**BELLEVILLE COMBINED LICENSE APPLICATION – RESPONSE TO REQUEST FOR
ADDITIONAL INFORMATION – GROUNDWATER**

Reference: Letter from Joseph Sebrosky (NRC) to Andrea L. Sterdis (TVA), Request for
Additional Information Letter No. 063 Related to SRP Section 02.04.13 for the
Belleville Units 3 and 4 Combined License Application, dated July 3, 2008

Subject: Groundwater as discussed in the Final Safety Analysis Report

Attachment 02.04.13-04A - Revised FSAR Figure 2.4.13-201

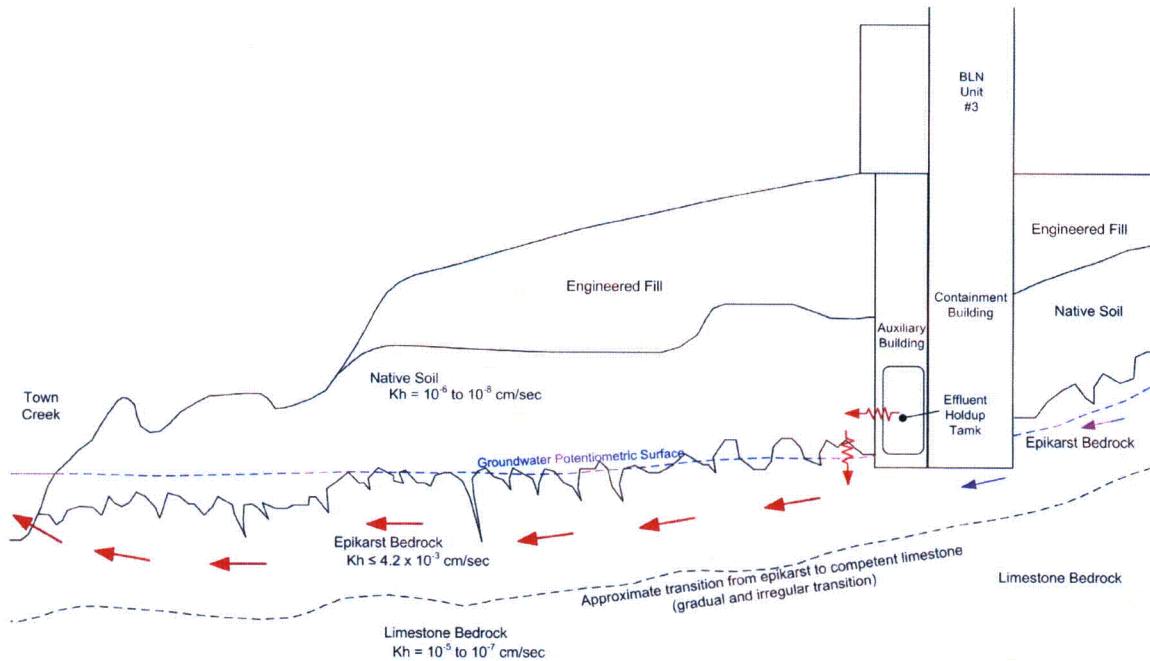
e) Attachment 5, item 32 of the May 13-16, 2008 trip report stated that TVA should provide an SME to clarify whether the contaminant source is assumed to be directly in the saturated zone as illustrated in Figure 2.4.13-201. If so, explain the use and impact of the contaminated and unsaturated zone parameters. The applicant stated the area was based on a 2 meter deep volume sitting atop the saturated zone.

Commitment: The applicant will revise the figure.

FSAR Figure 2.4.13-201 has been updated as identified in the Application Revisions section below and shown in Attachment 02.04.12-04A.

COLA Part 2, FSAR, Chapter 2, Figure 2.4.13-201 will be replaced with the revised figure in Attachment 02.04.13-04A.
